AUDIT REPORT **IG-05-023**

SPACE SHUTTLE ORBITER WIRING INSPECTION

July 14, 2005

National Aeronautics and Space Administration

Figure 1. Wiring Bundles Within the Crew Module of Orbiter Atlantis

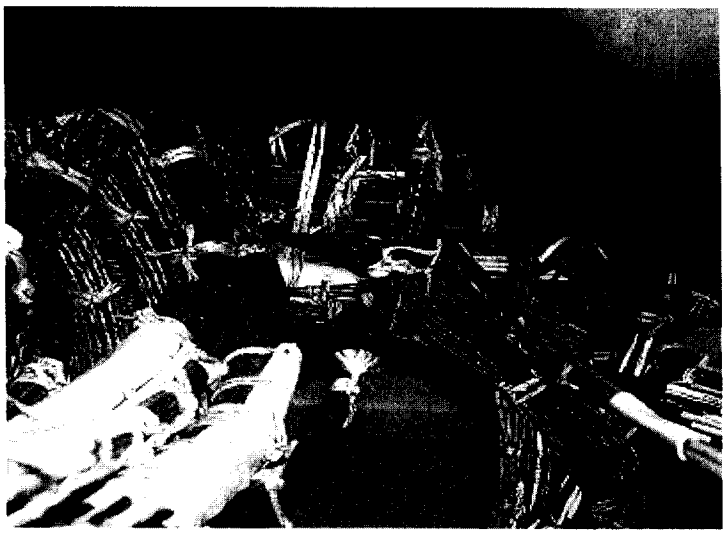
Visual inspections of orbiter wiring involve examining the outer wires of a bundle and not the wires inside the bundle. Wires inside the bundle are inspected only when insulation damage is detected on the outer wires. The inspection then includes a 360-degree check of loose wires and the area of insulation damage. Figure 1 shows wiring bundles within the crew module of the orbiter Atlantis.
